STATE OF TENNESSEE
DEPARTMENT OF ENVIRONMENT AND CONSERVATION
DIVISION OF MINERAL AND GEOLOGIC RESOURCES
3711 MIDDLEBROOK PIKE
KNOXVILLE, TENNESSEE 37921-6538
PHONE (865) 594-6035 STATEWIDE 1-888-891-8332 FAX (865) 594-6105

Mining Facility Inspection Report

NPDES permit number: TN0063606

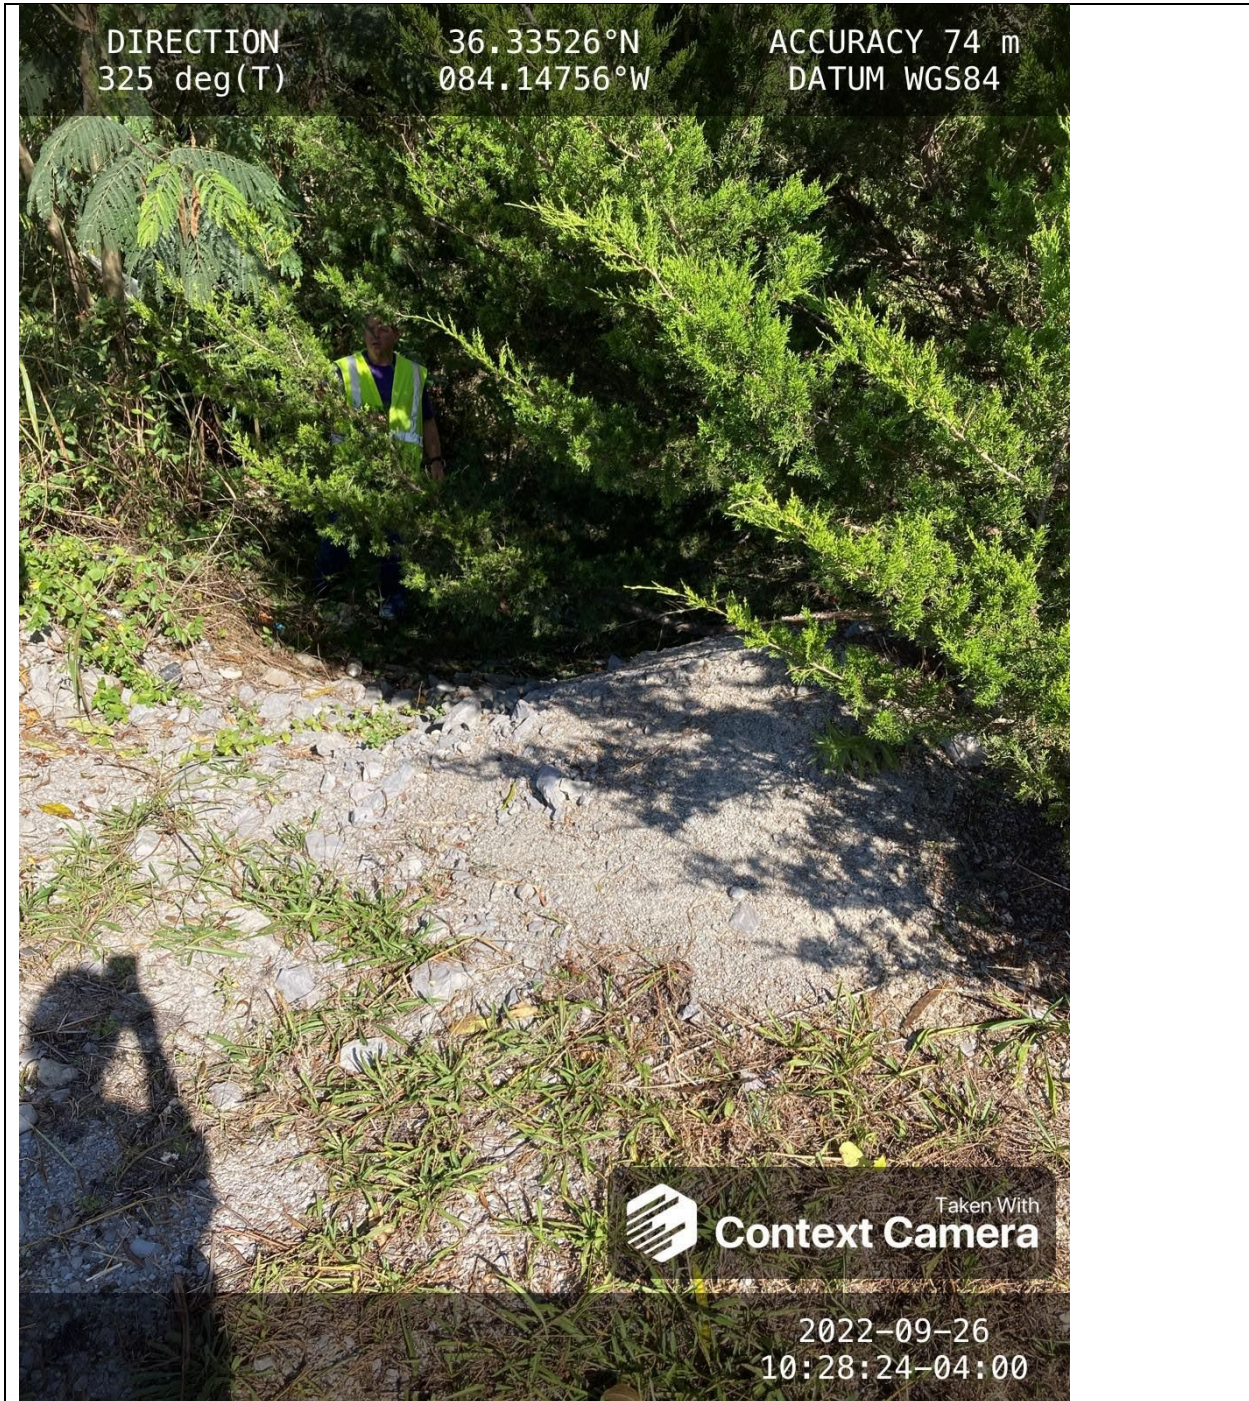
Item 10: Water from the parking area makes it to Pond 001 through this hole in the berm.

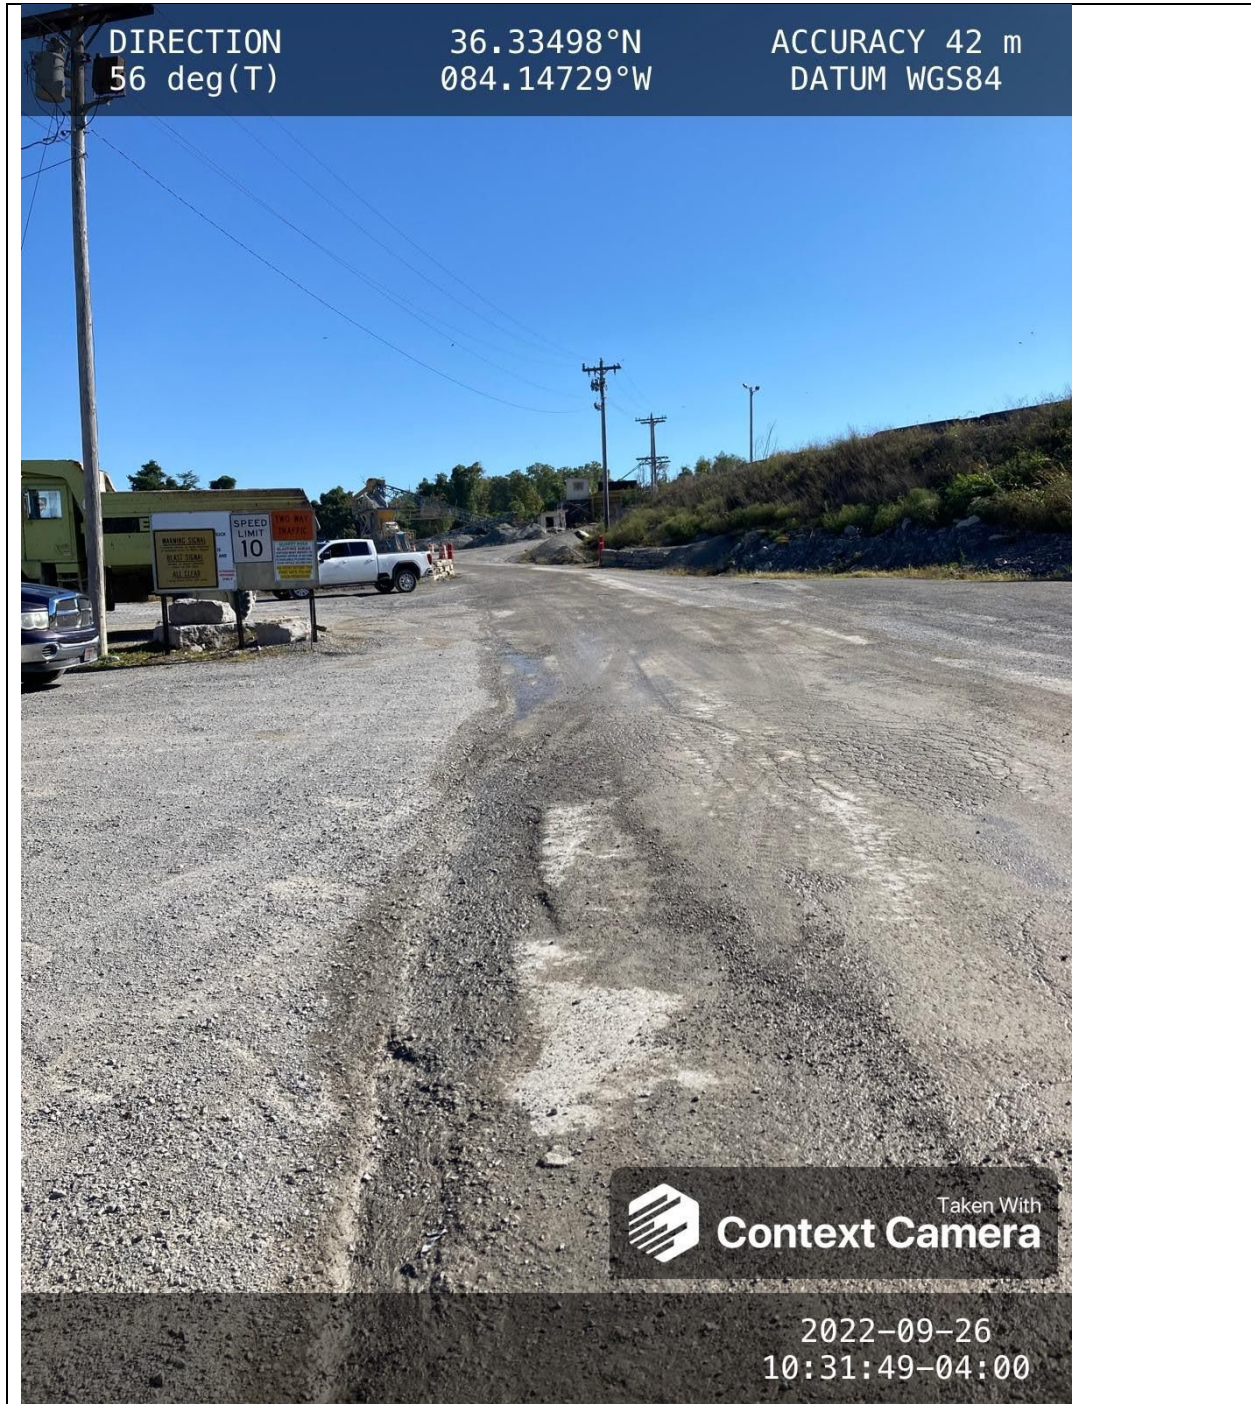
Item 11: Another view at a way water gets to Pond 001. The Pond 001 size/location was not clearly defined. This pond needs to be cleaned out and more clearly defined with an outfall point.

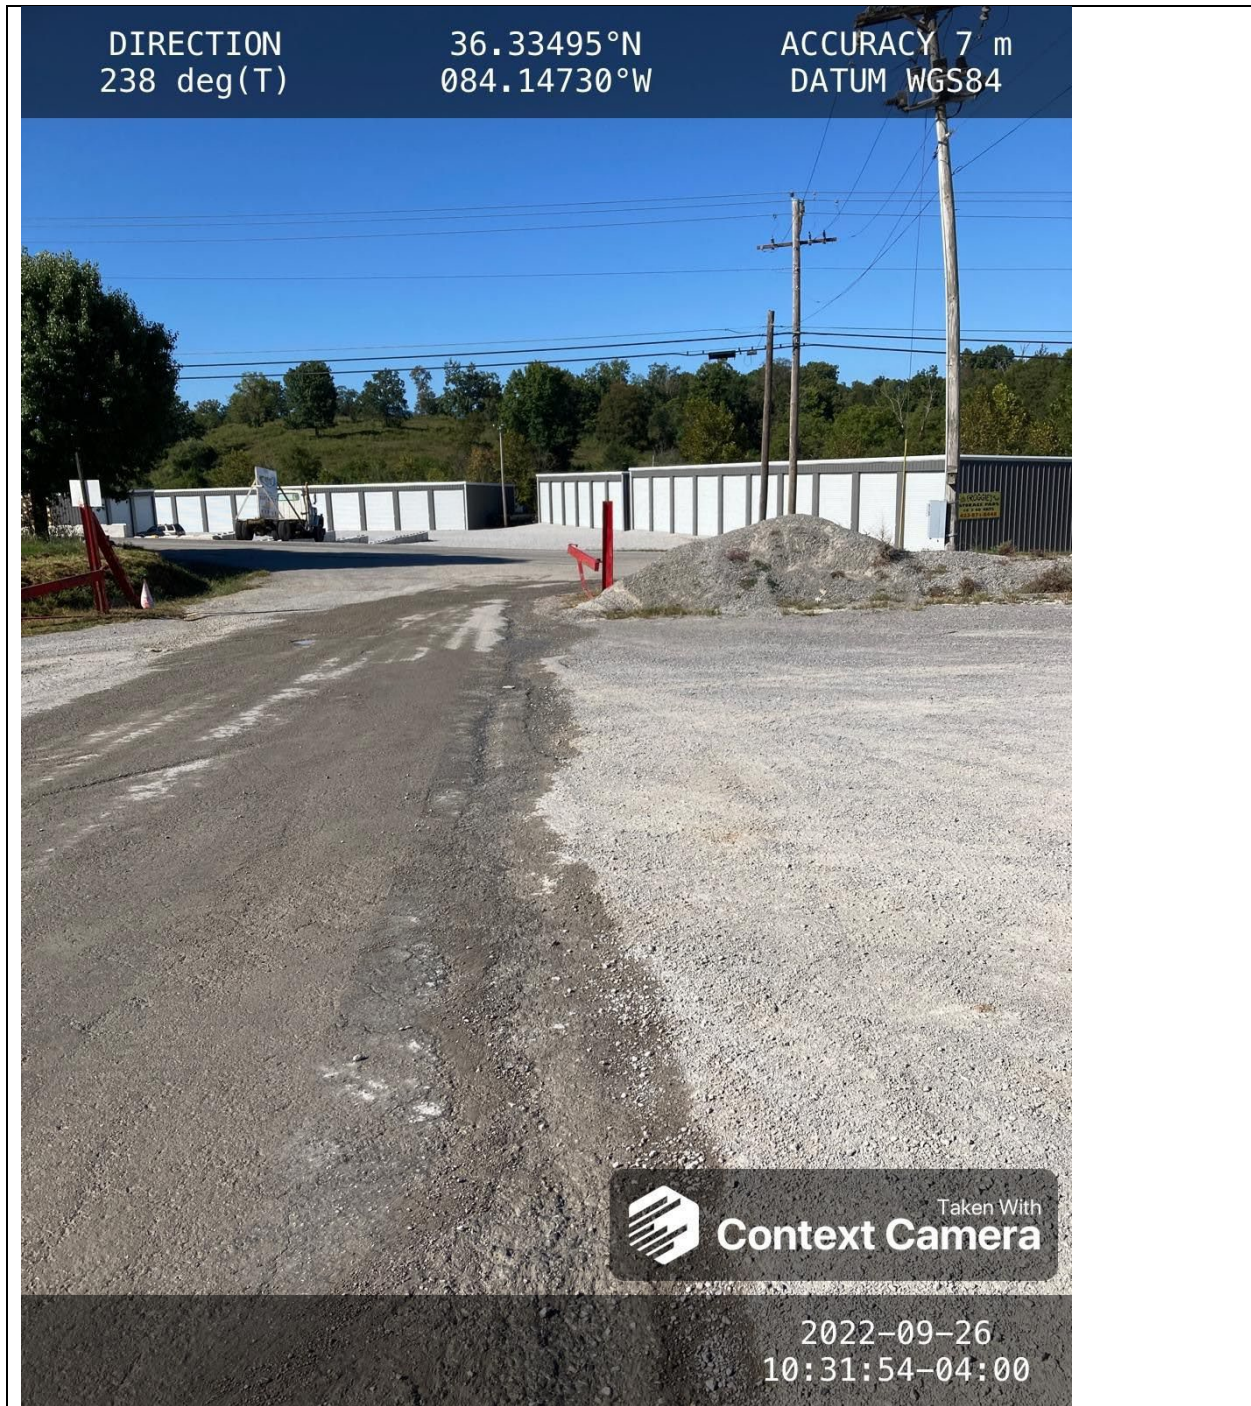
Item 12: View of the entry/exit road that has evidence of dust suppression water flowing on it.

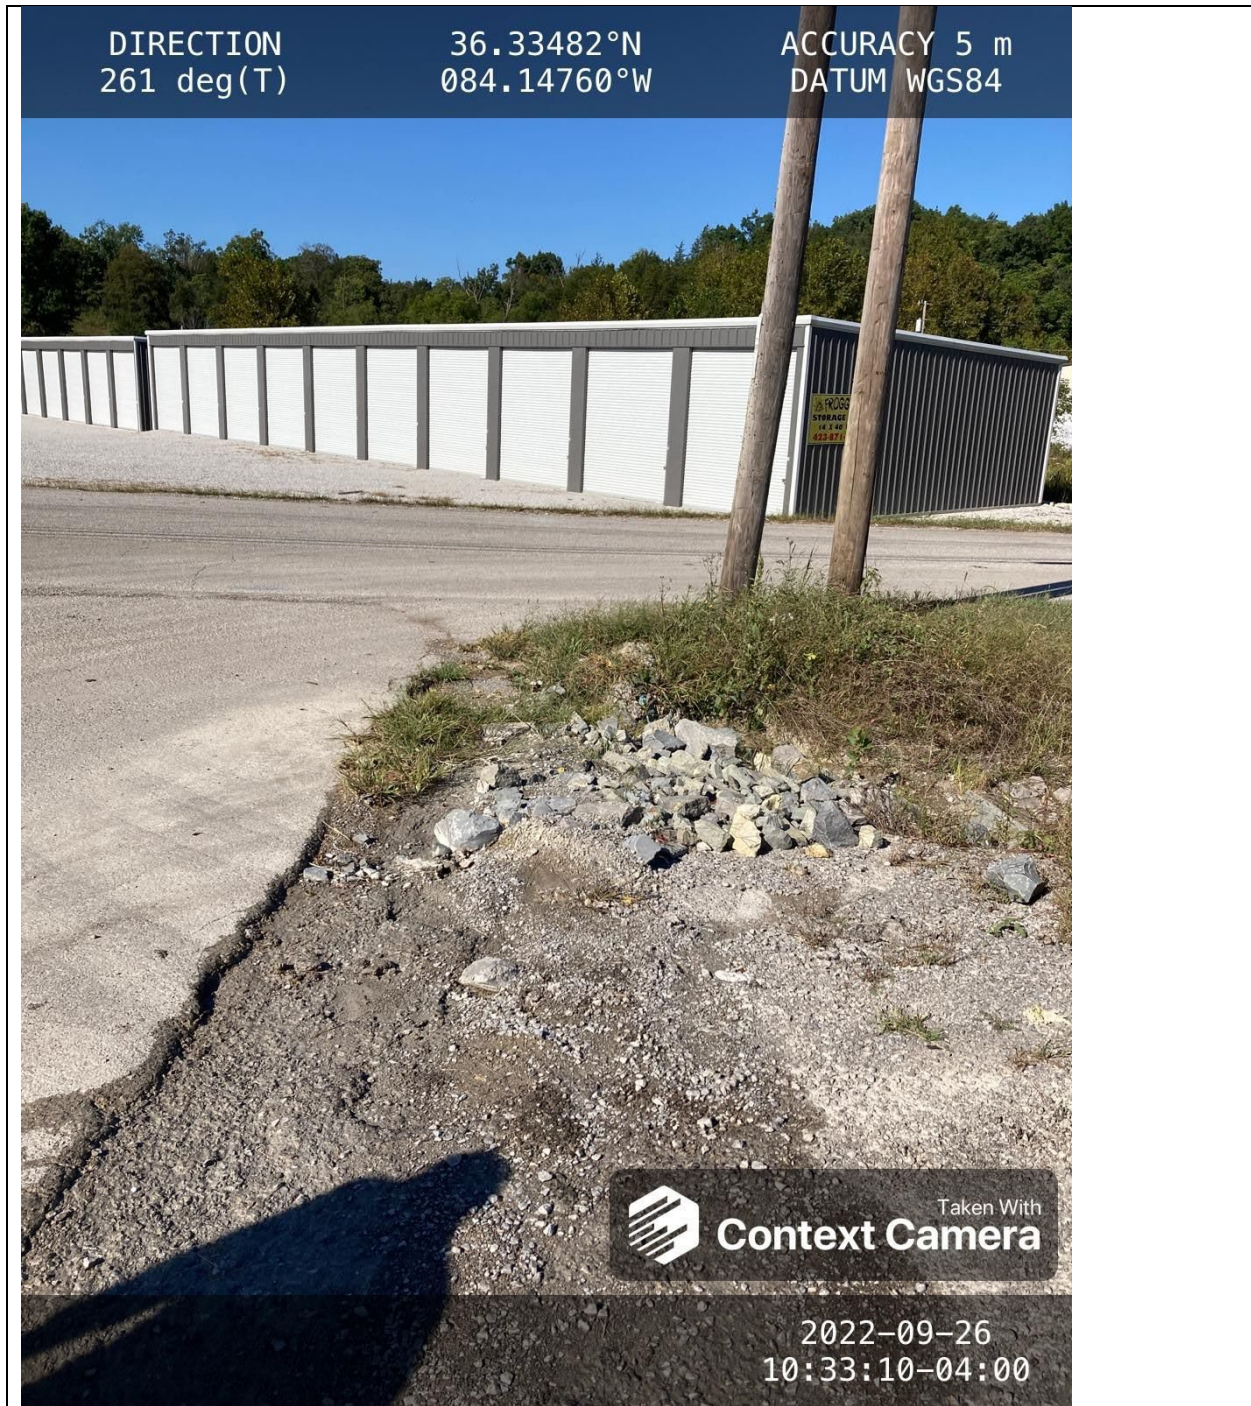
Item 13: Another view of the dust supression water flowing offsite. This water should be monitored in a potential stormwater monitoring point.

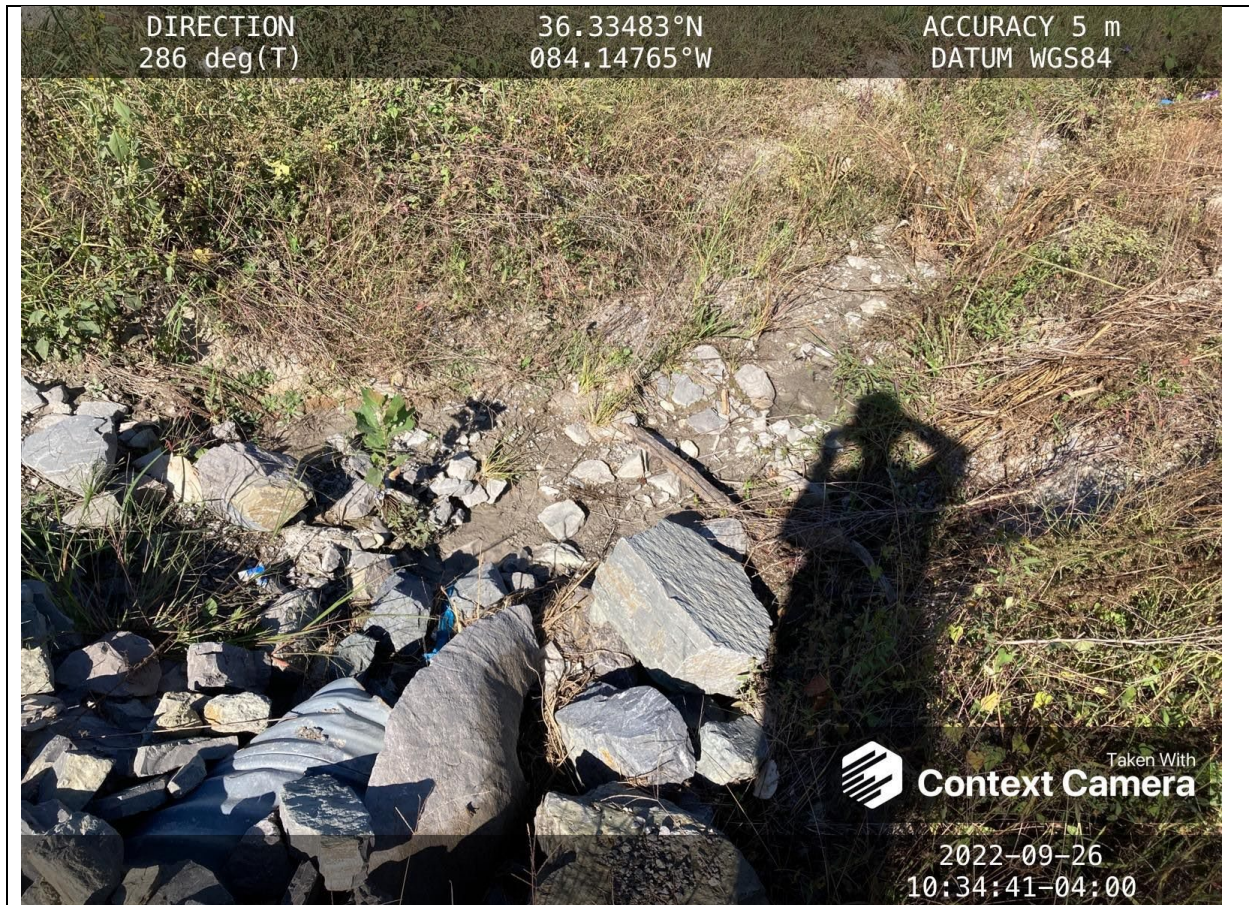
Item 15: Picture showing the water making it offsite and to a ditch at the public road.

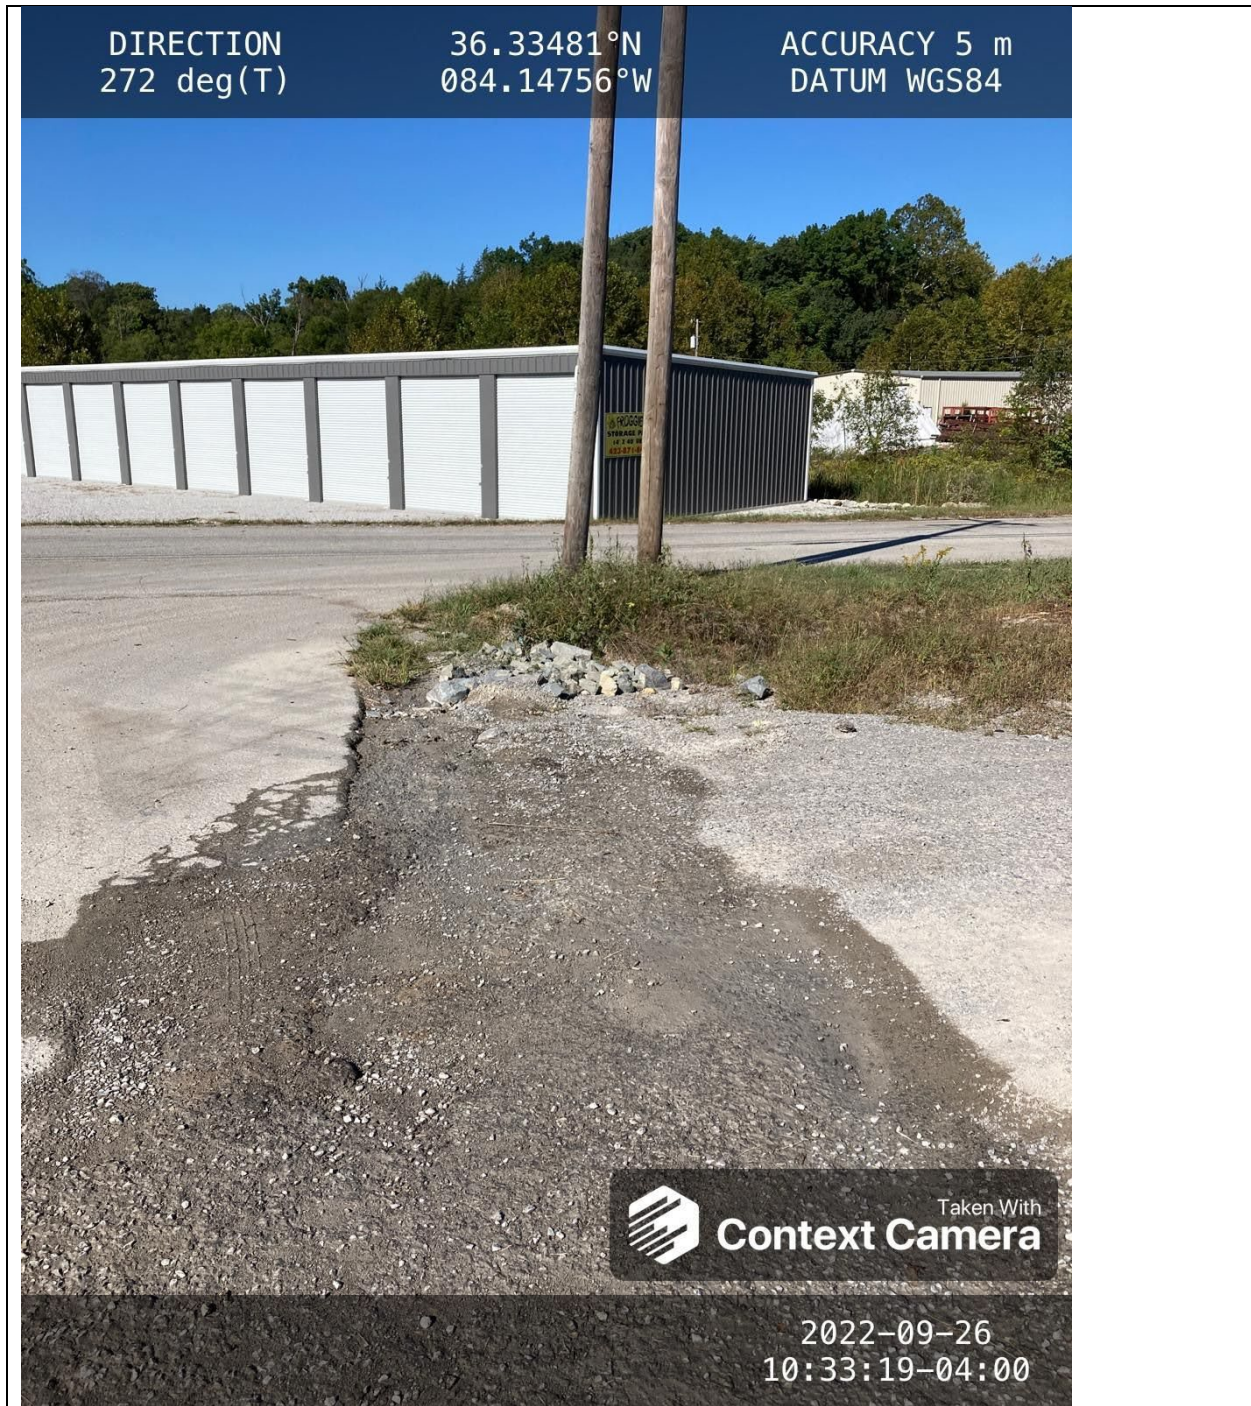
Item 17: Another view of the place the water makes it to from the entry/exit road. Sediment is clearly visible in the culvert. This water should be monitored prior to making it offsite.
